Your ref : 2016/2700/P + 2723/L

Application references 2016/2700/P + 2016/2723/L : extensions to 8 Prince Albert Road, Camden

Representations on behalf of Mr and Mrs Carroll : 7 Prince Albert Road, Camden

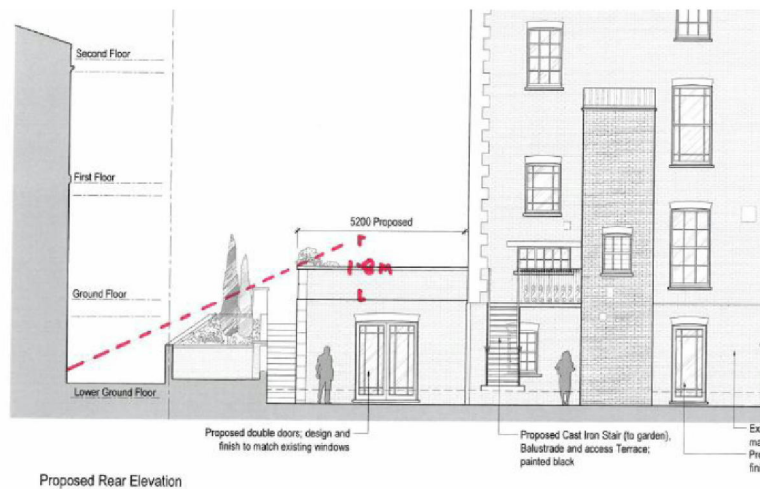
The only plan available which shows the relationship of the extension to no 7 is the one above taken from the applicant's tree constraint plan. My clients are concerned about the extent to which the extension is encroaching towards their property boundary. At its closest point, this will only be 2.6m from the boundary wall. On the contrary, the property of our clients sits 4.2 m (approx.) from that wall.

Lower ground floor side windows to no 7

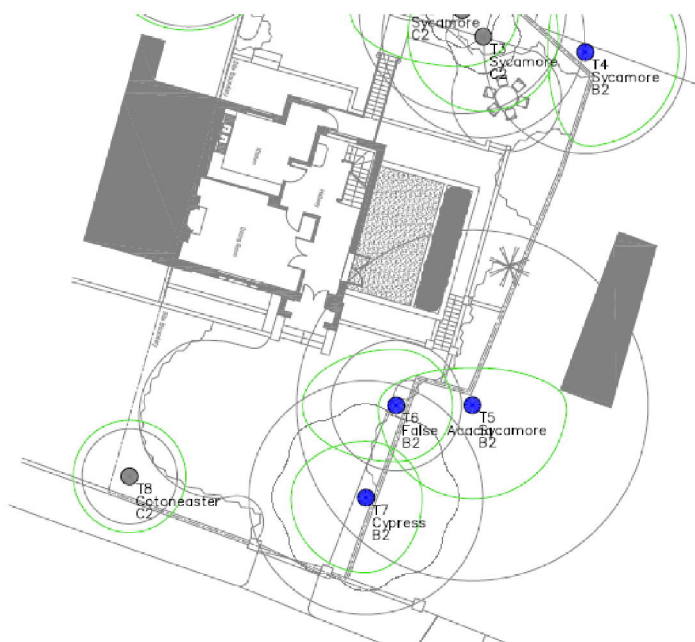
The proposals have a direct, adverse impact on the residential amenity of no 7 by virtue of overlooking and loss of privacy caused by the roof terrace proposed. As the photographs below illustrate, no 7 has habitable room windows facing no 8 on its side elevation at lower ground, ground and first floor levels. These windows directly face no 8 and as the diagram above demonstrates, a person standing on the roof terrace will be able to see directly into both sets of windows which serve main habitable rooms. The planter proposed presumably has the function of keeping people away from the shared boundary but as the diagram above demonstrates, it is not sufficient to prevent a loss of privacy occurring. The occupiers of no 7 currently have only a plain gable end facing them with no overlooking from no 8. The proposal introduces a significant degree of overlooking into their windows which is neither justified nor necessary.

The roof terrace should be deleted from the scheme in its entirety and if not, the applicant refused.
